STAFF REPORT

NEW BEDFORD HISTORICAL COMMISSION MEETING

CASE # 2020.22: CERTIFICATE OF APPROPRIATENESS

32 William St (Map 53 Lot 147)

32 WILLIAM STREET EXISTING CONDITIONS

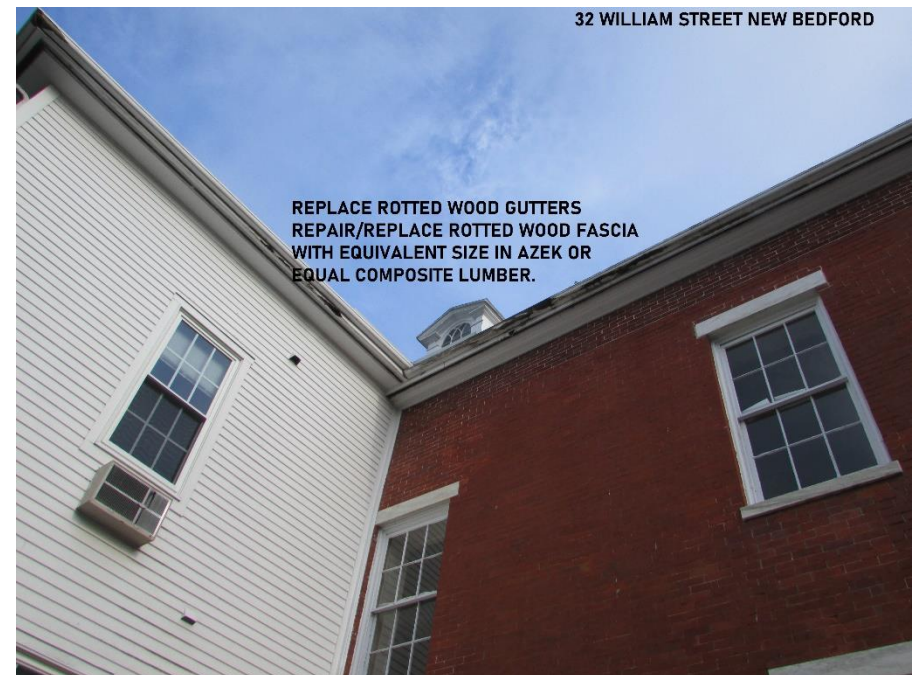
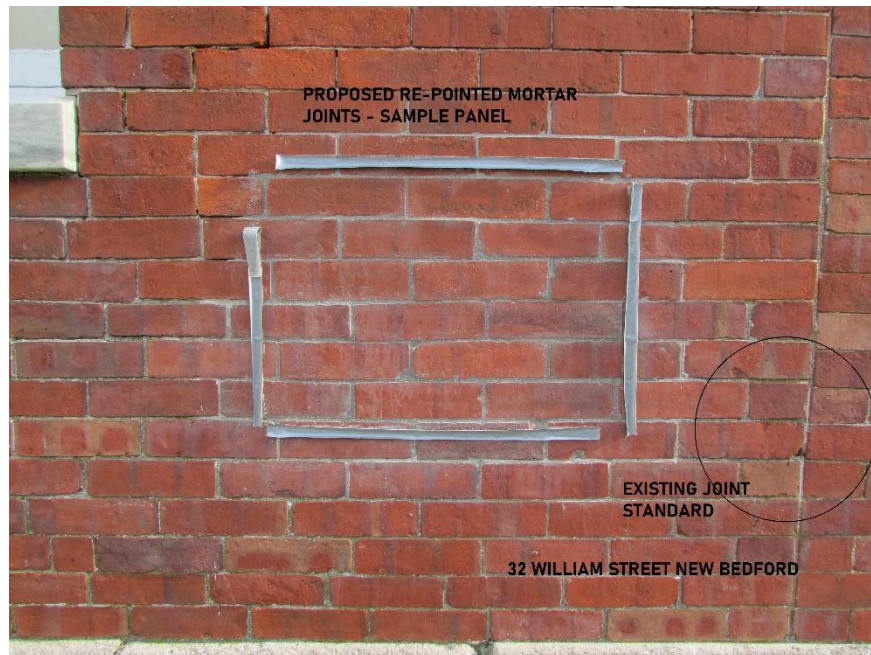
The applicant's agent came before the Commission in September for a preliminary review of the proposed scope of work. At that time a brick repointing mock-up by a previous masonry contractor was found to be unsatisfactory by Historical Commission Staff, the applicant and the applicant's architect.

Subsequently, a new masonry contractor has executed a new mock-up which has been found acceptable by Historical Commission Staff and the applicant's architect.

Repair and re-point all masonry on exterior of building. Joints shall be cleaned using hand-tools only, with particular attention to matching existing, pencil-thin mortar joints. Mortar shall match the make-up, texture, color, dimensions and profile of the existing brickwork. A sample panel showing the expected standards to be matched for the balance of the has been executed on the north-east corner of the building. **See photo.**

The masonry at 32 William Street has a very thin joint, often referred to as a “butter joint”. The thinness of the mortar joints does not allow room for power tools, and hand raking of the joints must be executed carefully.

The site mock-up has been executed well and the Commission may wish to have the masonry contractor contact Commission Staff prior to commencing the work to ensure follow- up consistency in the execution throughout the project.
